# UNITED STATES PATENT AND TRADEMARK OFFICE

10/668,763

# Office Action Summary

## **DETAILED ACTION**

FIG. 4

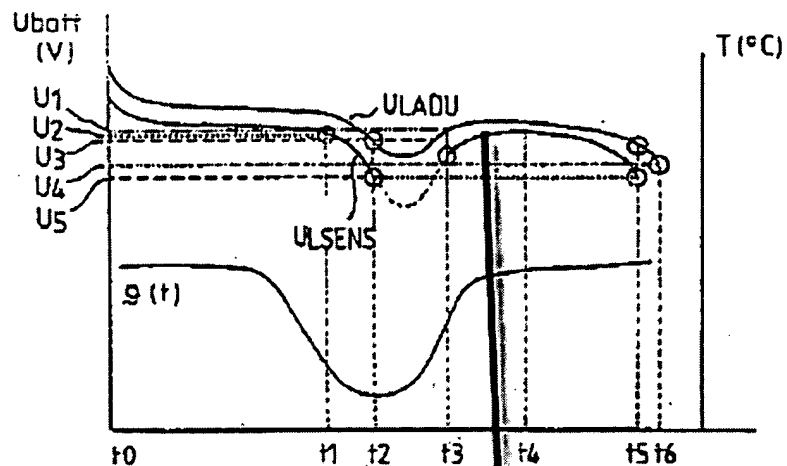
operational threshold voltage and the one or more operating condition (fig. 5, PS0-PS4); determining an operational threshold capacity using the unloaded operational threshold voltage (fig. 5, PS1-PS4), and estimating the usable battery capacity based on the present battery capacity and the operational threshold capacity (fig. 4, fig. 5, PS0-PS4).

Rompe discloses 'means for measuring battery capacity' in fig. 4 and 5, unit PS0-PS5, where as battery capacity decreases, the load of scanning is decreases as to conserve energy, in PS4, no more scanning of the items, just monitor the voltage takes place, if battery voltage reach level U3 in fig. 4, state will change to PS3 at a reduce scanning of the items (load). Rompe clearly discloses 'means for measuring battery capacity'.

FIG. 5

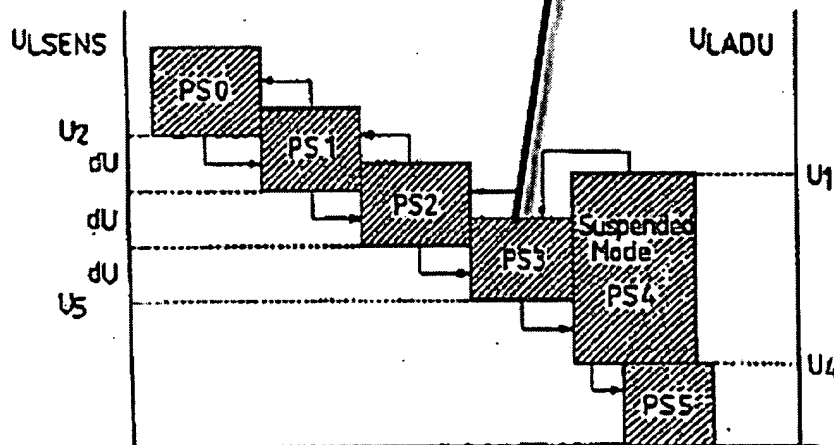
mobile device is shut off (fig. 5, PS4, PS5), and at least one operation of the mobil device remains operable (fig. 5, PS4, PS5); determining an unloaded operational threshold voltage of the mobile device based on the loaded

Rompe clearly discloses "determining a present unloaded battery voltage based on the present unloaded battery voltage and one or more operating condition" in fig. 5, state PS0-PS4, where present unloaded battery voltage based on the present unloaded battery voltage and one or more operating condition.

Rompe also clearly discloses "determining a present battery capacity using the present unloaded battery voltage' in fig. 5, PS0-PS4 where Rompe determining a present battery capacity using the present unloaded battery voltage.

Rompe also clearly discloses "determining an operational threshold capacity using the unloaded operational threshold voltage" in fig. 5, PS4, PS5, where Rompe determining an operational threshold capacity using the unloaded operational threshold voltage.

Rompe also clearly discloses "estimating the usable battery capacity based on the present battery capacity and the operational threshold capacity" in fig. 5, PS0-PS4 where Rompe 'estimating the usable battery capacity based on the present battery capacity and the operational threshold capacity".
